# Improving the Analysis of the Martin Drake Power Plant

How HDR's Study of Alternatives Related to  
Martin Drake's Future Can Be Improved

**Prepared for Sierra Club**

December 19, 2013

**Figure 3-1 Year-on-year Sales Growth Forecasts**

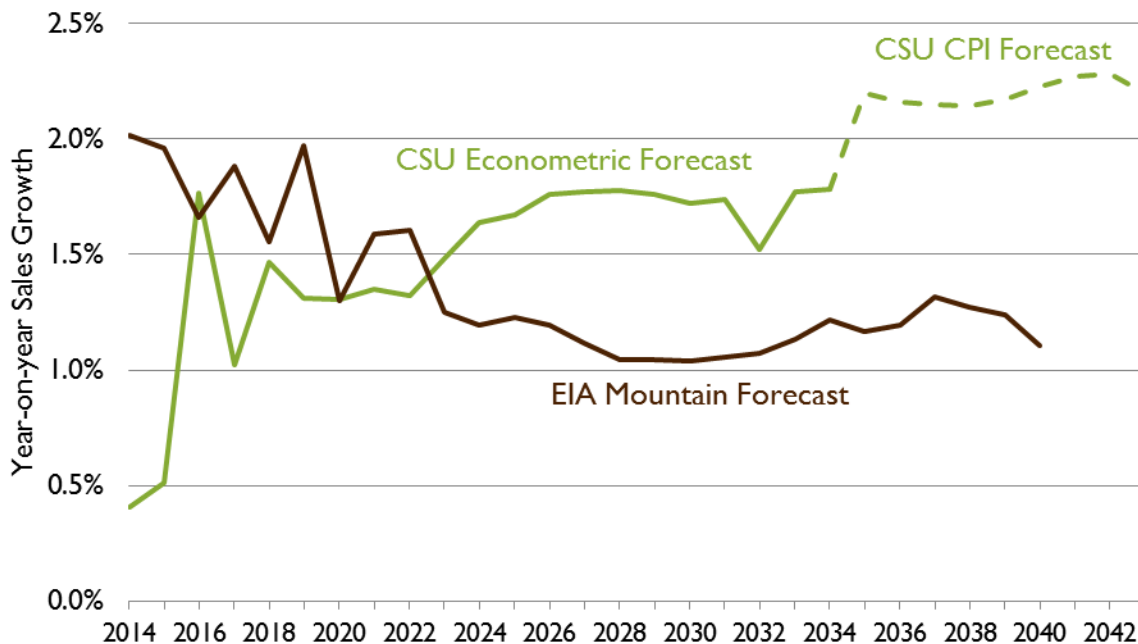
Mexico—and comparisons should be made with care. Nevertheless, this region is generally expected to have substantial growth, yet the EIA expects electricity consumption to grow more slowly than the forecast used by HDR. Figure 3-1 contains the year-on-year sales growth in the CSU and EIA Mountain forecasts. Note that CSU’s forecasted growth is substantially higher than the EIA’s forecasted growth, both in the latter years of CSU’s econometric forecast (2024 – 2034) *and* in CSU’s CPI-based forecast (2035 – 2043). By 2040, CSU’s forecasted annual growth is *twice* the EIA’s forecast.

Synapse believes that HDR should be using a forecast much closer to the EIA forecast for years 2024 – 2043. HDR’s use of an overly-high load forecast tends to favor scenarios that keep Drake on line through the end of the study period.

Figure 3-2 CSU-to-EIA Coal and Gas Forecasted Price Ratios

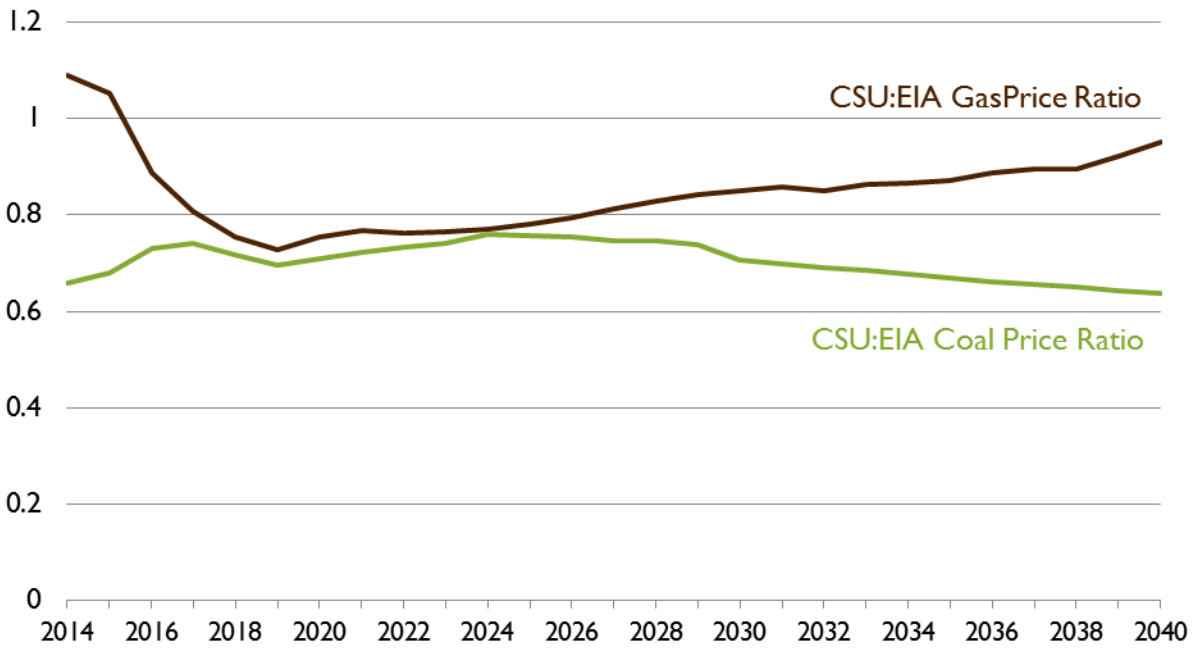
The HDR report overstates the relative value of Drake because it relies on unrealistically low fuel price estimates. Because coal and natural gas fuel the vast majority of electricity generated by CSU now and in the foreseeable future, using robust price forecasts for these fuels is essential. These costs can be divided into two portions: the cost of the fuel itself, and the cost of delivery. HDR’s fuel prices are significantly lower compared to the forecasts made in the U.S. Energy Information Administration’s *Annual Energy Outlook 2013* (AEO 2013) —particularly the price used for coal.

Fuel price estimates include both commodity and transportation components. The cost of fuel transportation to specific CSU sites is highly dependent on a number of complex details that are not included in the HDR report or CSU’s 2012 IRP. Therefore, Synapse cannot comment on the appropriateness of these estimates. However, the estimated commodity prices for coal and gas used in the HDR study are unrealistic because they deviate significantly from EIA estimates. The coal mine mouth prices used in the HDR report are 25 – 35 percent less than EIA estimates over the entire 2014 – 2040 timeline.<sup>15</sup> The gas prices, while more in line with EIA estimates, are also a bit lower than EIA’s—a difference that grows markedly in the out years (Figure 3-2). A wide variation in the near term can be explained if HDR’s prices reflect CSU’s current supply contracts, but as those contracts come up for re-negotiation, CSU’s price of coal will converge to the market price. This price will likely be much higher than the estimates in the HDR report. The large coal deviation and smaller natural gas deviation don’t simply cancel each other out when considering alternatives—they lead to a bias in favor of coal.

**Figure 3-3 Synapse and HDR CO<sub>2</sub> Price Trajectories**

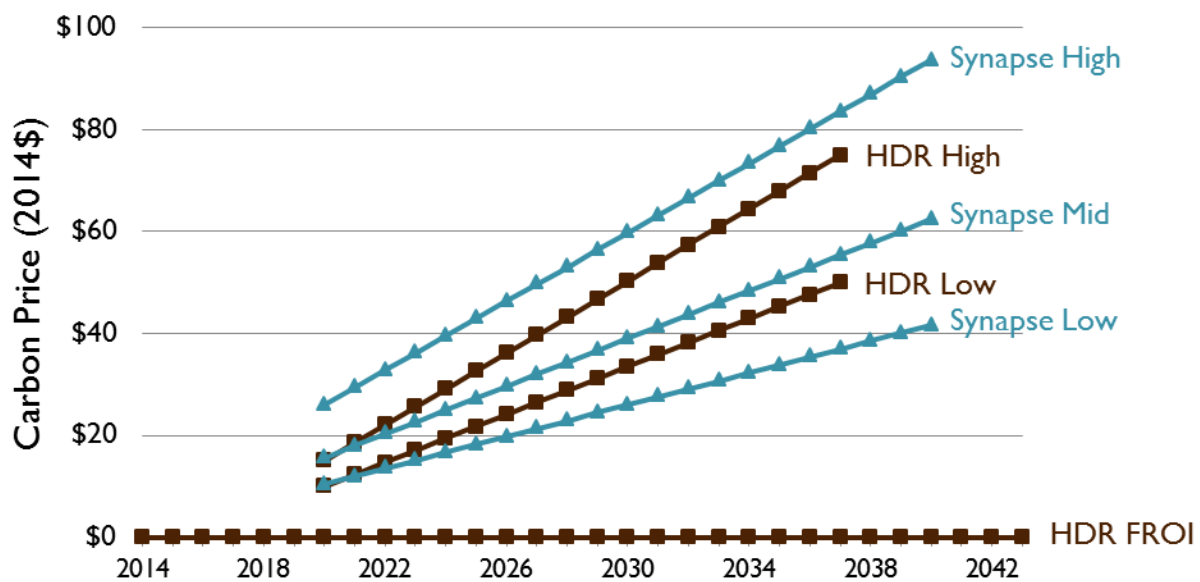
Company,<sup>27</sup> and Portland General Electric<sup>28</sup> all included CO<sub>2</sub> prices in their most recent IRPs. By not including any carbon price in the FROI analysis, HDR's FROI calculations presume that there is zero chance that there will be any state, regional, or national carbon pricing scheme—be it a tax, cap and trade, or otherwise—between today and 2043. This position is at odds with HDR's statement on the likelihood of greenhouse gas emissions throughout its report, with Synapse's analysis, and with the planning models used by electric utilities across the country. Synapse recommends that HDR include a (non-zero) carbon price when calculating FROI in the base case. As shown in Figure 3-3, the November 2013 Synapse Mid forecast is similar to the HDR Low forecast, and would be a reasonable base case carbon price assumption to use in HDR's FROI calculations.

Omitting a carbon price in the FROI calculation is a substantial error, as it fails to include a substantial future cost. Ignoring these costs causes Drake retrofit FROI costs to appear too low relative to early retirement scenarios. Similarly, scenarios with higher quantities of renewable generation installed in earlier years have a more favorable FROI than the HDR study suggests, once realistic forecasts of CO<sub>2</sub> emissions costs are considered.
